## ***LT384 Tealing to Westfield Overhead Line (OHL) 400 kV Upgrade***

## Volume 4: Appendix 6.2 - Scoping Opinion

**Scoping Opinion on behalf of Scottish Ministers under the  
Electricity Works (Environmental Impact Assessment) (Scotland)  
Regulations 2017**

**Tealing to Westfield Overhead Line 400kV Upgrade  
(Reconductoring) Project**

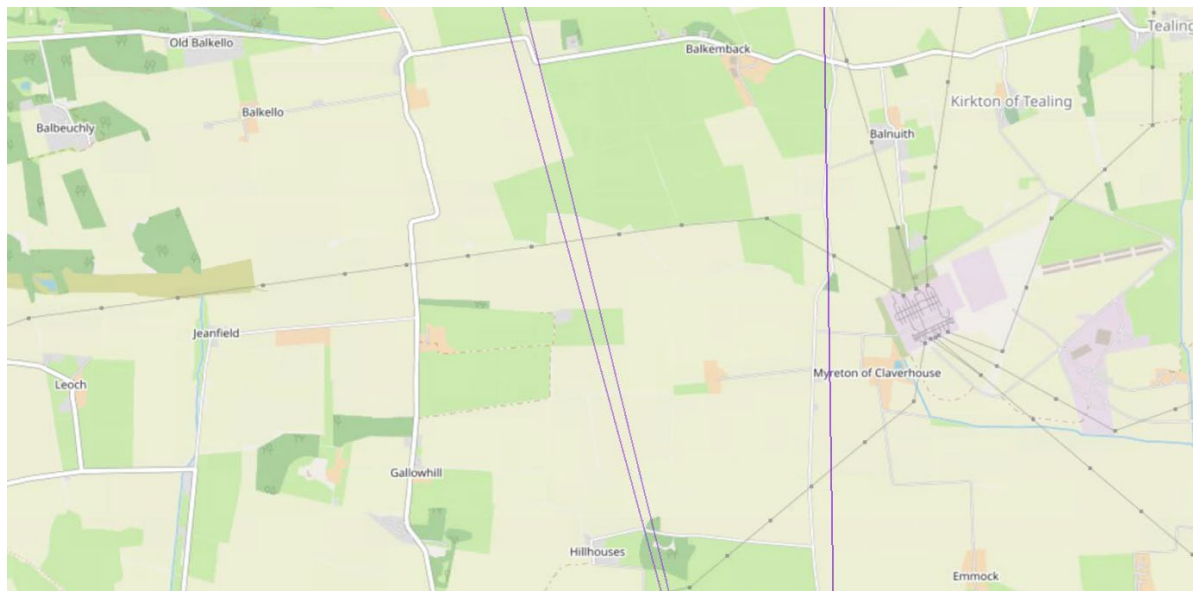
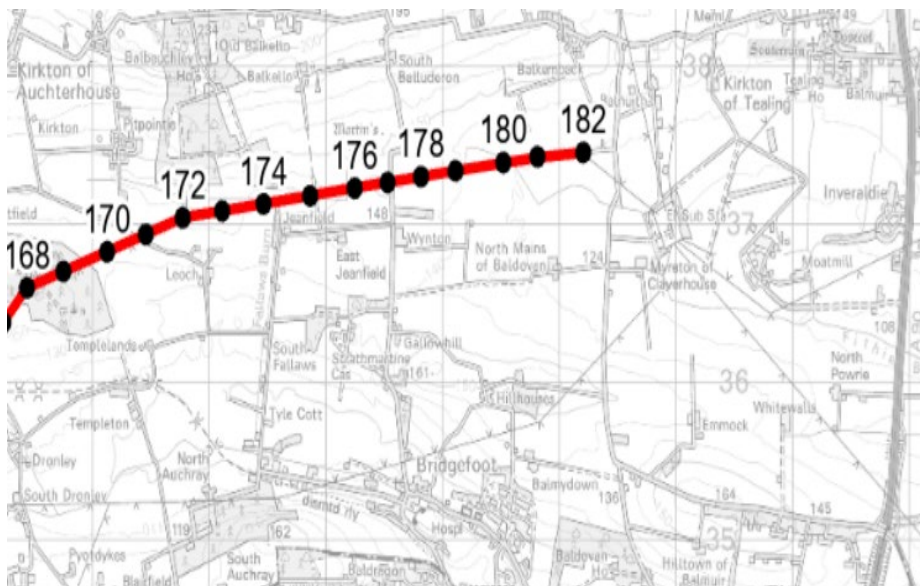
We have studied this proposal using attached with respect to EMC and related problems to BT point-to-point microwave radio links.

The conclusion is that the project indicated will not cause interference to BT's current and presently planned radio network.

Please see below where we have active radio links near the towers below. As these are being replaced and no mention of any changes to their height these are approved. If there are any changes, please let us know. The only changes I could see are: **to mitigate a 132kV clearance constraint, Towers 155 and 156 may need to be extended in height by using a 3m long body extension or possibly inverting tower cross arms and/ the use of suspended tension sets may suffice; and o Due to constraints associated with the conductor type, coupled with an inability to utilise mid-span joints, it may be the case that between Towers 156 and 167 and between Towers 119 and 136 a suspension tower may need to be replaced with a tension tower of a similar size within the vicinity (approximately 80m) of the existing tower.** These towers are clear of any active/planned radio links.

BT requires 100m minimum clearance from any structure to the radio link path. If any changes are proposed to the information supplied, please let us know and we can reassess this for you.
